Access Compliance Report

Public Rights-of-Way

(Curb Ramps)

Intersection ID: 23217	Main Street: GLENEAGLES_RD	Cross Street: QUAIL_HOLLOW_RD	Location: NE
ADA ID: 5C812136F6B3	Ramp Type: Perp	Initial Pass/Fail: Fail	Overall Compliance: No
Severity Score: 25			
Codes/Mitigation Info/Possible Solution		Field Measurements/Component Compliance

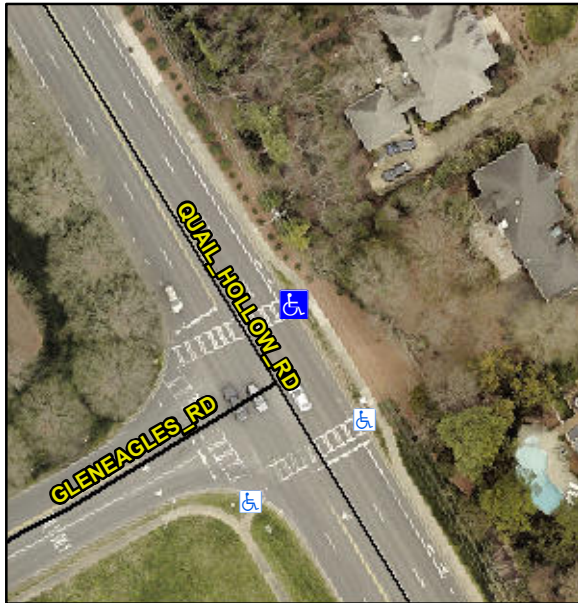
Not Found, R304.2.2, R304.5.3

Compliance	Description	Data	Compliance	Description	Data
N/A	Ramp Length (in)	65.0	No	Ramp Slope (%)	10.3
Yes	Ramp Width (in)	49.0	No	Ramp XSlope (%)	6.6
N/A	Flare Type LT	N/A	N/A	Flare Type RT	N/A
N/A	Flare Slope LT (%)	N/A	N/A	Flare Slope RT (%)	N/A
N/A	Flare Traversable LT?	N/A	N/A	Flare Traversable RT?	N/A
N/A	Landing Length (in)	N/A	N/A	DWS Provided?	N/A
N/A	Landing Width (in)	N/A	N/A	DWS Contrast?	N/A
N/A	Landing Slope (%)	N/A	N/A	DWS Length (in)	N/A
N/A	Landing X Slope (%)	N/A	N/A	DWS Full Width?	N/A
N/A	Landing Curb? (Y/N)	N/A	N/A	DWS Offset (in)	N/A
N/A	Shared Landing?	N/A			
N/A	Gutter Ponding?	N/A	N/A	Gutter Slope (%)	N/A
N/A	Gutter Lip Ht (in)	N/A	N/A	Gutter X Slope (%)	N/A
N/A	Painted X Walk1?	Yes	N/A	Painted X Walk2?	N/A
	X Walk 1 Direction	To W		X Walk 2 Direction	N/A
N/A	X Walk 1 Width (in)	111.0	N/A	X Walk 2 Width (in)	N/A
	X Walk 1 Slope (%)	8.7		X Walk 2 Slope (%)	N/A
	X Walk 1 X Slope (%)	3.5		X Walk 2 X Slope (%)	N/A

Remove & Replace Entire Ramp.
